Re: 533 Elizabeth St. Apartment House

The City has received an application requesting that the Building Board of Appeals consider an exception to the 2015 Michigan Residential Code described as follows:

APPLICATION FOR VARIANCE AND/OR TIME EXTENSION HOUSING BOARD OF APPEALS

Ewing Application for Variance – 533 Elizabeth St.

BASEMENT FLOOR PLAN @ 1/4" SCALE

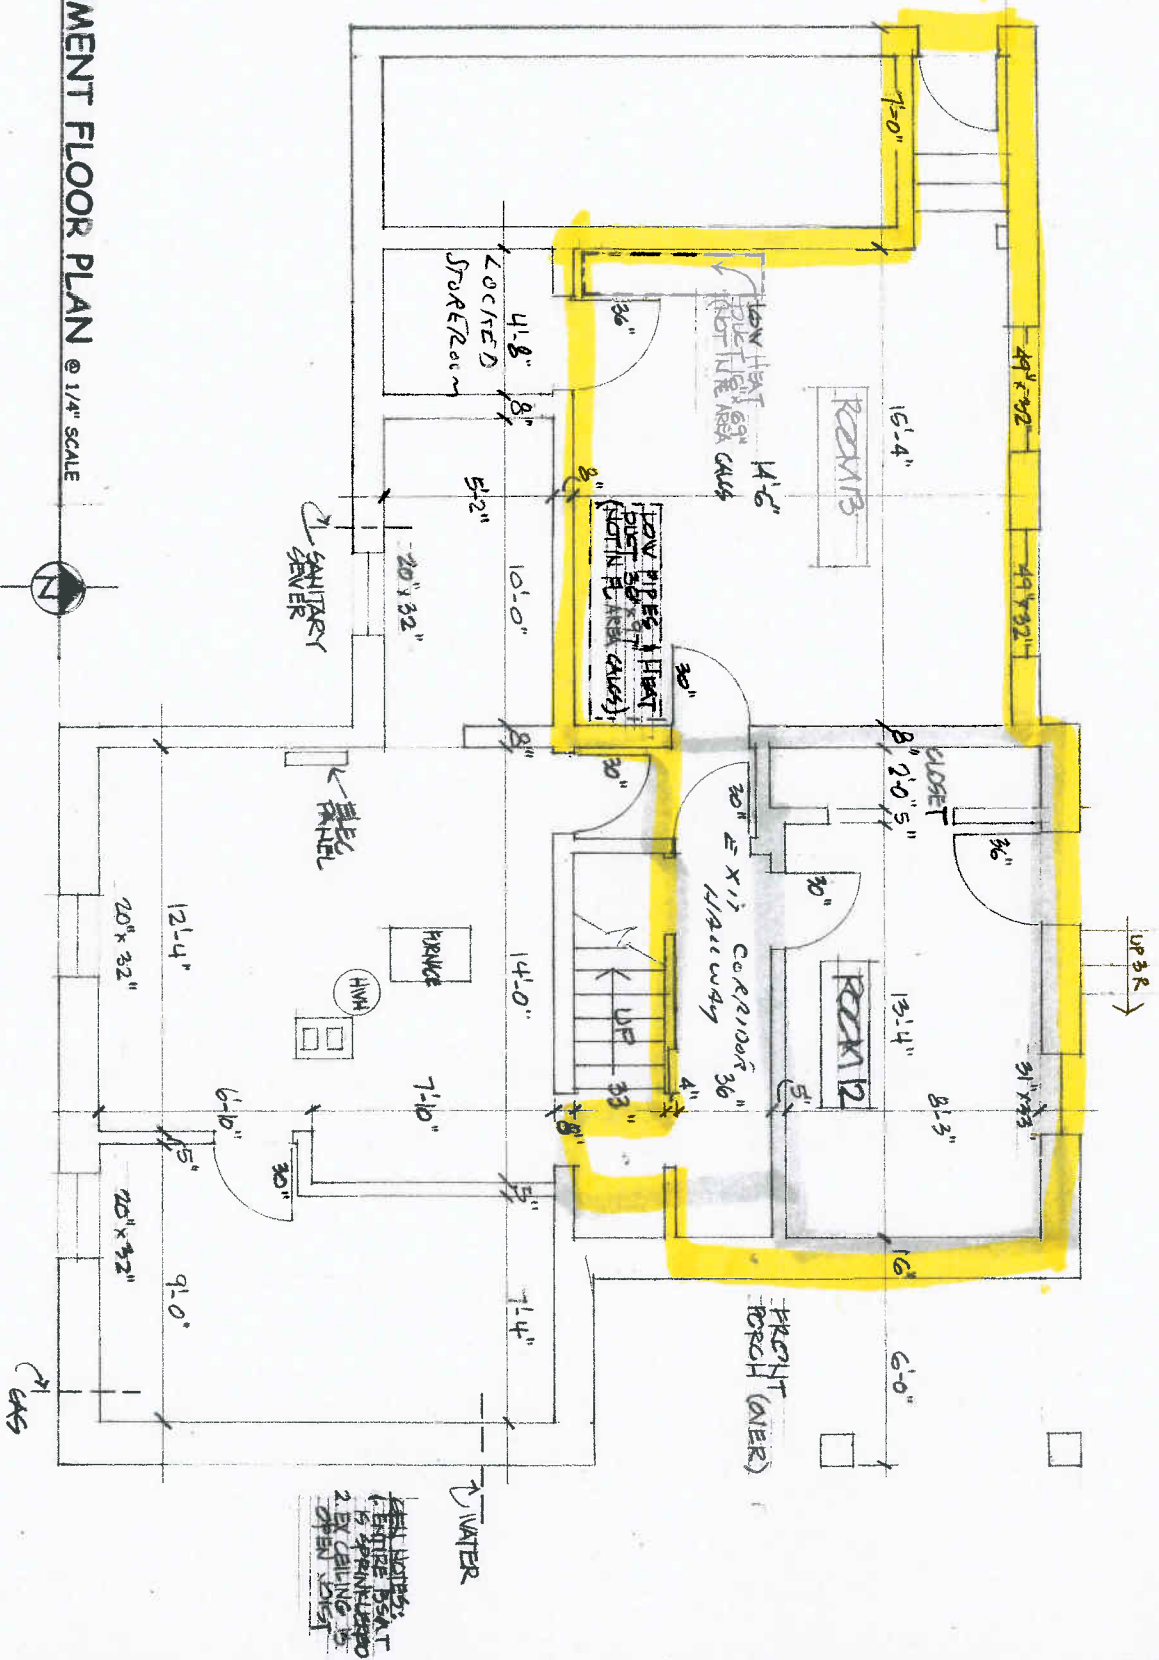
Location: Room #12, the smaller room in the front-east end of the north side of the basement

Proposed dimension: 6 ft. 5 in. for room #12

Location: Room #13 in the west end (back) of the north side of the basement

Proposed dimension: Height of 6 ft. 3 in. for room #13

Location: Exit corridor to bottom of stairs to first floor. Corridor starts at room #13 goes east past entrance to room #12 and around to the bottom of stairs to the first floor.

Proposed dimension: 6 ft. 4 in. for exit corridor

Room #13 facing west to outside exit

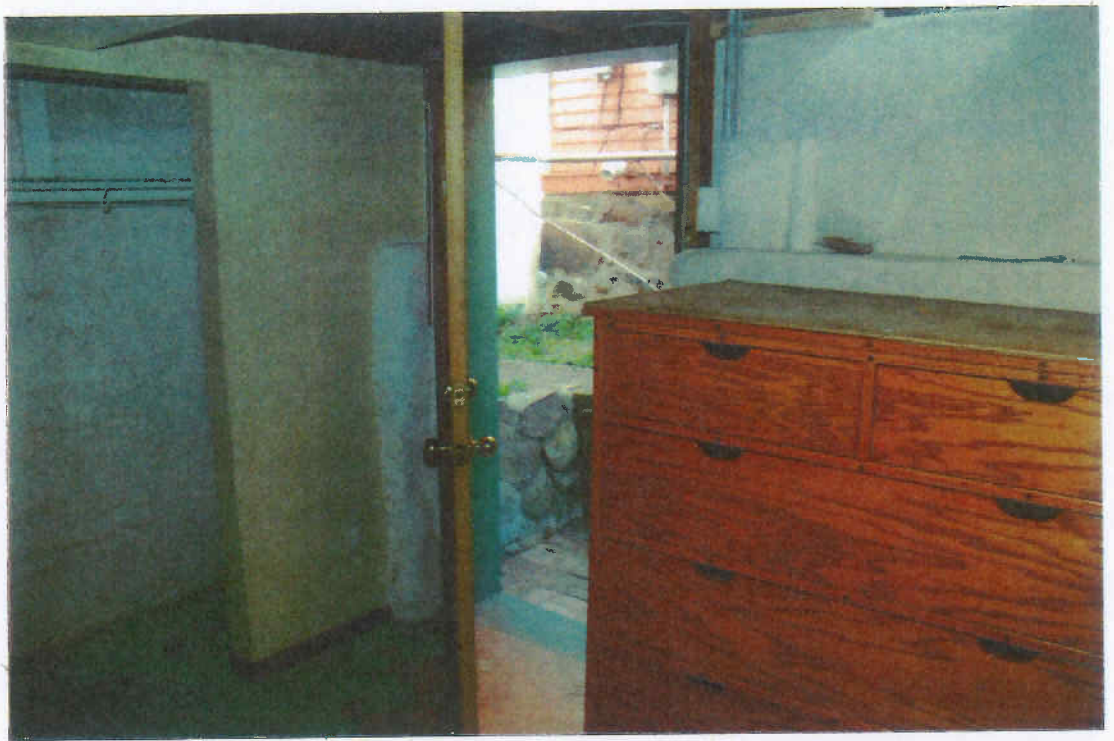
A Variance is required because: It is not possible to raise the building to create the required headroom in the Historic District. Maintaing the same cement floor as originally built will in my opinion (I am a licensed builder) maintain the best structural integrity of the building which has existed for about 100 years with no water leaks or foundation problems. A Variance will also retain the original floor drain (in the large room #13) which will no longer be feasible if the floor is lowered.

Under current requirements, a new cement floor after digging down, would have to have 4 inches of pea gravel plus 4 inches of concrete plus 5 to 10 inches for ceiling height and reinforcement. Reinforcing and extending the foundation walls 14-18 inches in order to remove the current cement floor and lower the floor is a big alteration to the building foundation and structure for just a few inches of ceiling height. Digging down to lower the floor in room #13 would eliminate the existing original floor drain in that room.

Room 12 Sprinkler pipe and Ducts A & B

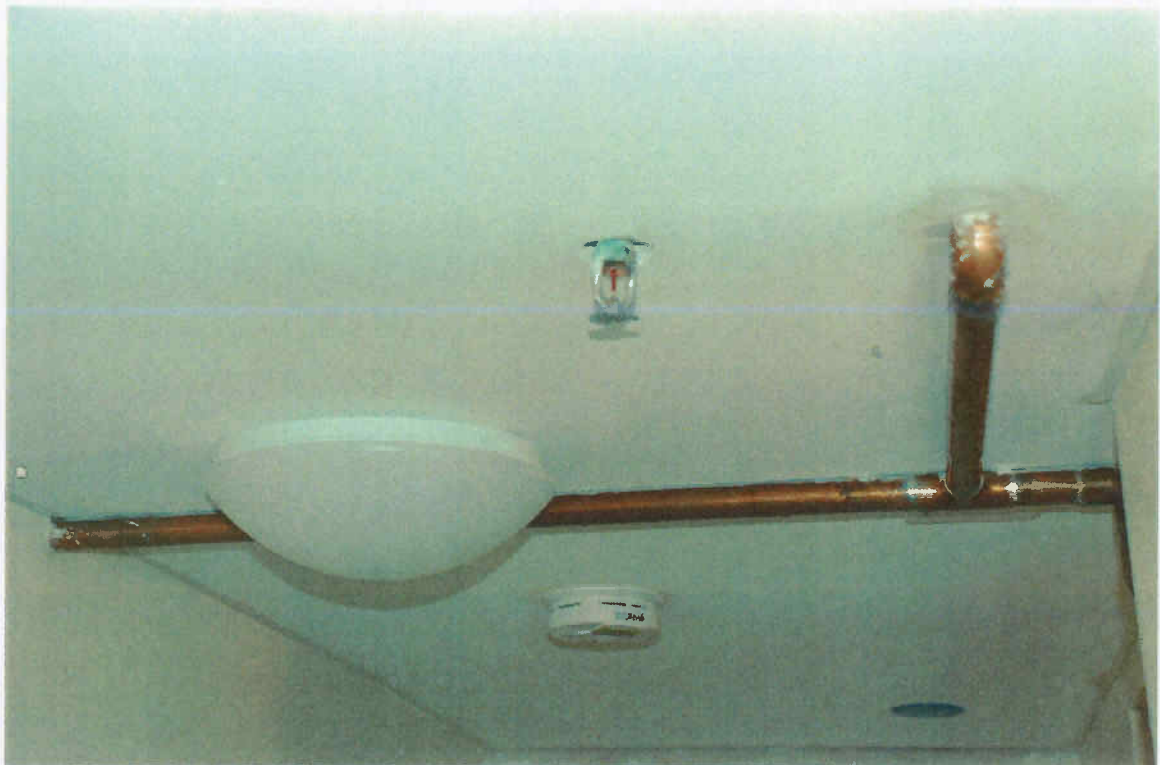
#1 Sprinkler head height is 6' 5" supply line to room 13 has a height of 6' 5"

A Duct is 7' 6" X 12" and has a height of 6' 2+"

B Duct near doorway is 5' 4" X 12"

Minimum height from floor is 6 ft. 5 in.

Room 13 Duct C

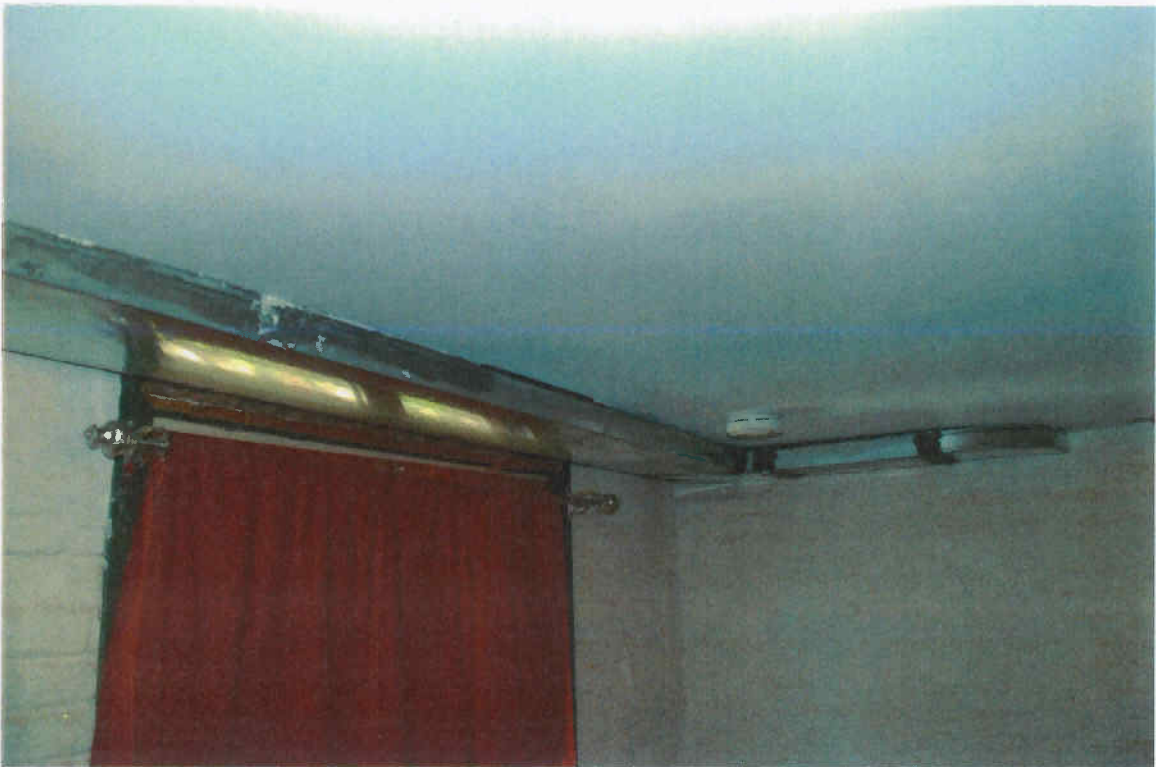
C Duct is 12 in X 12 in. and height is 6 ft. 2+ in.

D Duct in NE corner of room near window. This branch measures 34" X 12"

Minimum height from floor is 6 ft. 3 in.

E A continuation of Duct D. This branch measures 6 ft. 11 in. X 13 in. and is at the same 6 ft. 3 in. height

Duct work behind “the curtain” in Room 13
Shelves to be installed in this area under the duct

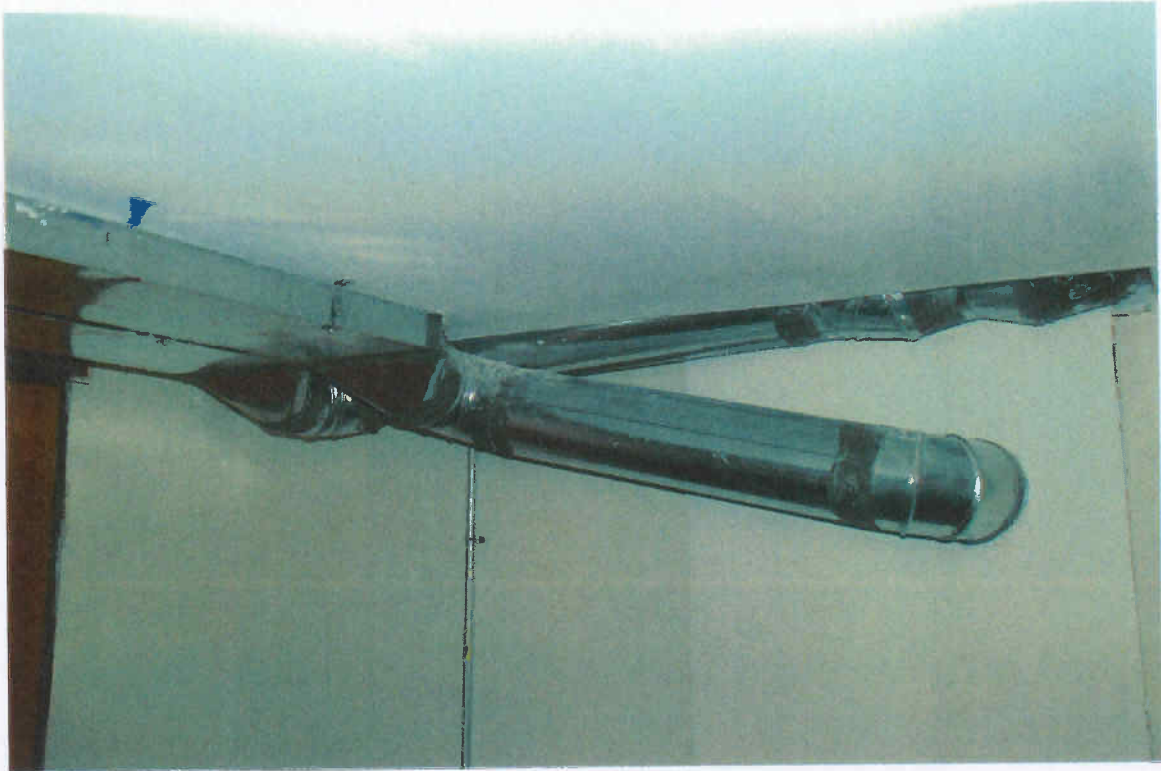
Duct work against West wall starting in the SW corner of the room is a delineated storage area where shelving will be placed and is not included in room sq. footage but the duct work in this area is 69 in. X 16 in. The duct work in this area of room #13 is excluded from the room area and will be closed off by a curtain wall which outlines a storage space. This is indicated on drawing. A curtain allows much more efficient use of this narrow space as built in shelving.
